UNITED WAMBO OPEN CUT COAL MINE PROJECT

RESPONSE TO INDEPENDENT
PLANNING COMMISSION
FEBRUARY 2019 PUBLIC MEETING

Response to Independent Planning Commission
February 2019 Public Meeting

Project Director: John Merrell
Project Manager: Kirsty Davies
Report No. 3509/R26
Date: April 2019

Figure 9 Measured annual average PM₁₀ concentrations at various rural and metropolitan locations across NSW

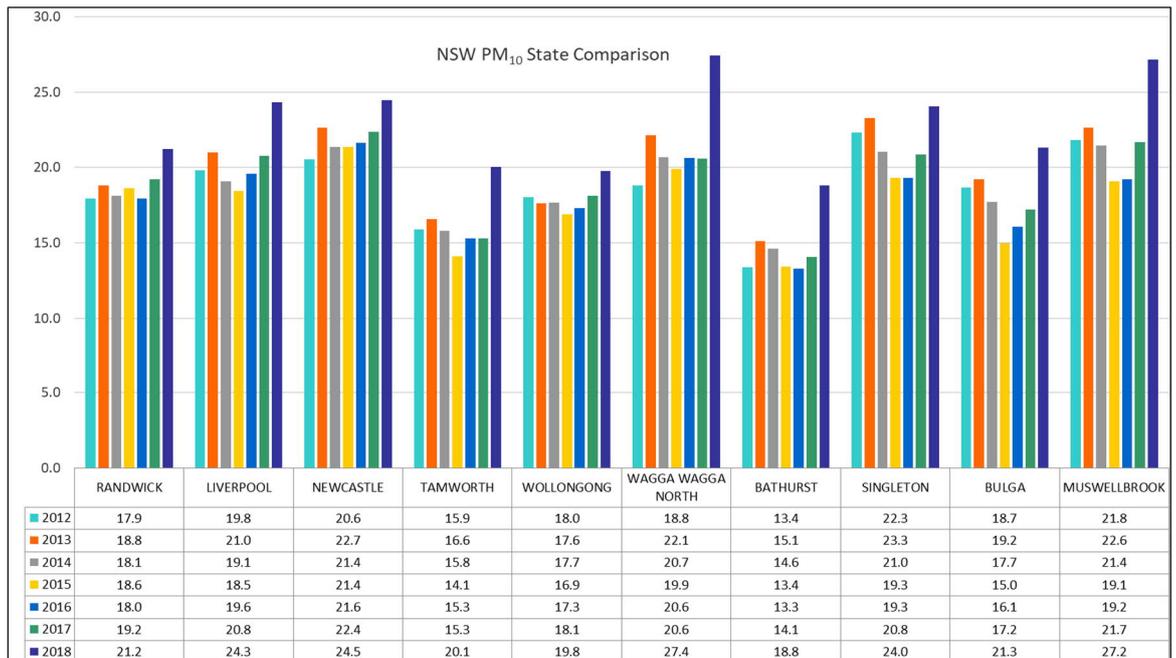
“Certainly last year had much worse air quality than 2014 and it’s our contention, really, that the proponent is measuring the impact of this mine on air quality in the Hunter region against a base year that is not the same as the current environment that people are experience.”

Higher than long-term average particulate matter concentrations in 2018, compared to previous years, is acknowledged but not unique to the Hunter Valley. This is demonstrated by **Figure 9** below which shows the measured annual average PM₁₀ concentrations at various rural and metropolitan locations across NSW.

The monitoring data from **Figure 9** show that PM₁₀ concentrations were higher in 2018 than in all previous years for all the listed rural and metropolitan locations, including at the main NEPM-defined “performance monitoring stations” in the Hunter Valley, namely, Singleton and Muswellbrook. That is, the higher particulate matter concentrations in 2018 were not unique to the Hunter Valley. The higher than average PM₁₀ concentrations have been influenced by lower than average rainfall (across NSW) from late 2017 through 2018 and an increased frequency of regional events such as dust storms which occurred across many parts of NSW.

The data from **Figure 9** also show that air quality in the Hunter Valley is not dissimilar to air quality at other regional and metropolitan locations, with the exception of Bathurst which has historically measured generally lower average PM₁₀ concentrations than other OEH monitoring sites. Note that including results from multiple monitoring sites located within reasonably close proximity (such as all other monitors in the OEH Upper Hunter air quality monitoring network) is not appropriate for this comparison. This comparison, and outcome, should be determined from data collected at “performance monitoring stations” as per the NEPM.

Finally, the data from **Figure 9** show that conditions in 2014 were, from an air quality perspective, close to the typical environment that people experience in the Hunter Valley. This conclusion is based on 2014 PM₁₀ concentrations that were almost identical to the long term averages from all available data.
